AGENDA

HISTORIC PRESERVATION ADVISORY BOARD MEETING
CITY HALL, 385 SOUTH GOLIAD, ROCKWALL, TEXAS
APRIL 20, 2023 IN THE CITY COUNCIL CHAMBERS AT 6:00 PM

HISTORIC PRESERVATION ADVISORY BOARD CASE MEMO

TO: Historic Preservation Advisory Board
DATE: April 20, 2023
APPLICANT: Fernando Hernandez
CASE NUMBER: H2023-004; *Certificate of Appropriateness (COA) for 406 Williams Street*

1 Front Elevation

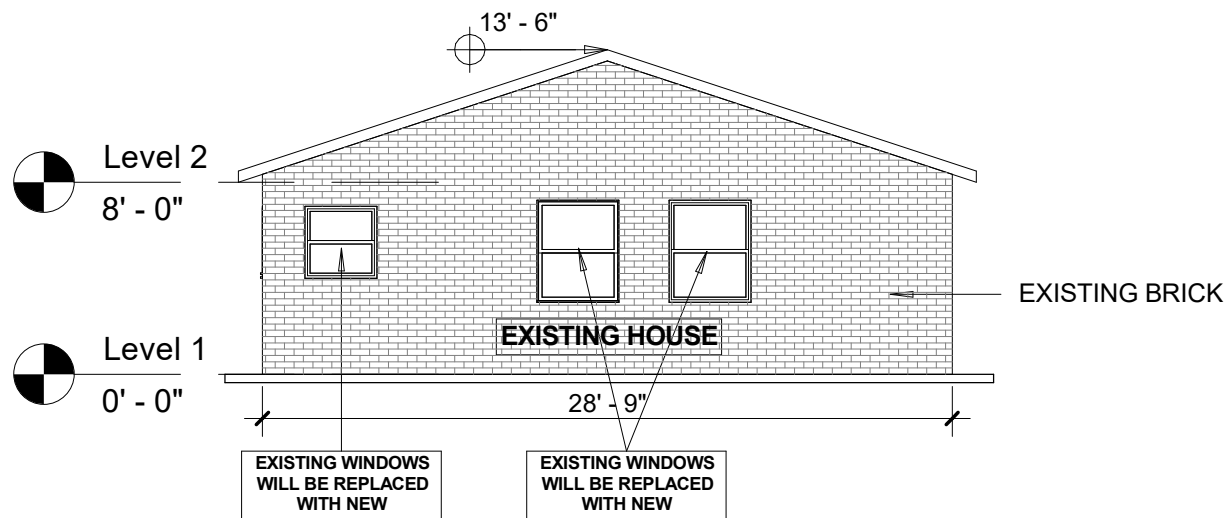
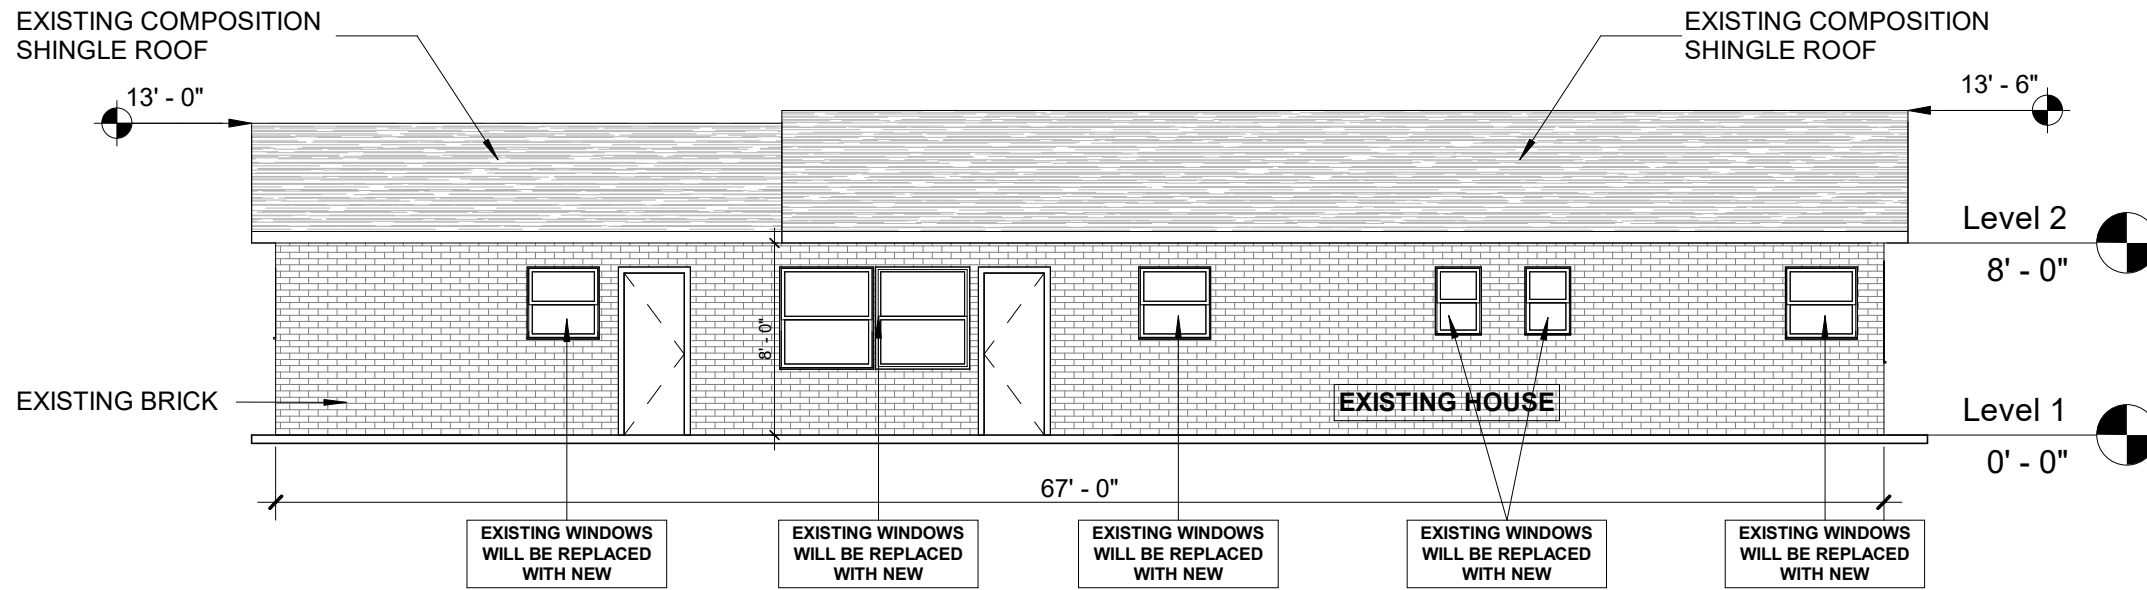
- (a) *Windows*. According to Section 07(C)(7), of Appendix D, *Historic Preservation Guidelines*, of the Unified Development Code (UDC), "(t)he overall relationship of the size, width, height and number of doors and windows on the exterior building facades should be typical of the style and period of the structure." In this case, the proposed building elevations appear to indicate that the size, width, and height are complimentary to the existing windows. Staff should note, that the existing windows appear to be aluminum framed, which is consistent with the time period of the home. That being said, the applicant has indicated the new windows will be vinyl, which -- *while being atypical with the time period of the home was constructed* -- are not an atypical upgrade for older homes in the area.

- (b) *Building Facades and Materials*. According to Section 07(C)(6), of Appendix D, *Historic Preservation Guidelines*, of the Unified Development Code (UDC), "(m)aterials, structural and decorative elements and the manner in which they are used...should be typical of the style and period of the existing structure." Based on the photo provided by the applicant the proposed garage doors are wooden and in a carriage style, while the previous garage doors appeared to be standard aluminum doors. That being said, Section 07(C)(6) continues by stating, "(n)ew additions, alterations and new construction should be visually compatible with neighboring historic buildings or structures." Staff reviewed the surrounding properties and found that the majority of the garage doors were aluminum, which would appear to make the applicant's request inconsistent with the neighboring historic buildings; however, aluminum garage doors are not of a typical style for the period of the existing historic homes, and the wood garage doors would present a more historically appropriate aesthetic.

- (c) *Paint and Color*. According to Section 07(M), of Appendix D, *Historic Preservations Guidelines*, of the Unified Development Code (UDC) "(b)rick, stone or other naturally or historically unpainted materials should not be painted unless the material has been painted before." In this case, the existing home has been previously painted and does not require the approval of the Historic Preservation Advisory Board (HPAB); however, the applicant has indicated to staff that they intend to paint the existing home and the new brick white, to create a consistent and updated look. Staff should note that the HPAB does not have discretion over this aspect of the case, unless, as mentioned previously, the material has not been painted before; however, the *Historic Preservation Guidelines* discourage "(f)lorescent and metallic colors." Based on this section of the code, the white should be an improvement to the existing yellow color.
